SERVICE BULLETIN

FUJI HEAVY INDUSTRIES LTD.

NO : FAS-069

1. SUBJECT : Improved Method for Exhaust Stack Installation.
2. AIRCRAFT AFFECTED : All FA-200 series aircraft.
3. PRIORITY : Desirable.
4. REASON : To prevent possible failure of exhaust stack attaching springs.
5. DESCRIPTION : Replace the existing plates, P/N 200-950057-003, with new plates, P/N 200-950060-003, and also add spacers and grommets for exhaust stack attaching springs.
6. ACCOMPLISHMENT : At option of operator.
7. APPROVAL : Not applicable.
8. PARTS REQUIRED : The following parts are required to accomplish this modification.

FIGURE 2 SECTION A-A

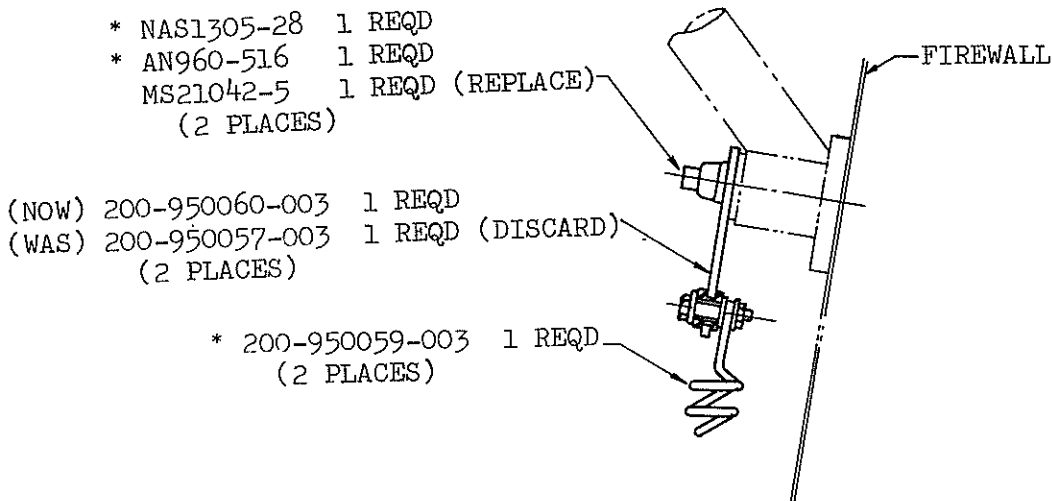
- (5) Remove existing plates (200-590057-003).
- (6) Attach springs (200-950059-003) to new plates (200-590060-003) with bolts (AN3-7A), nuts (NAS 679A3W), and washers (AN960C10). Use grommet (MS35489-38), spacer (NAS43DD3-24), and washers (0656102) between the bolt and the nut as shown in figure 2. Tighten the nut only finger-tight.
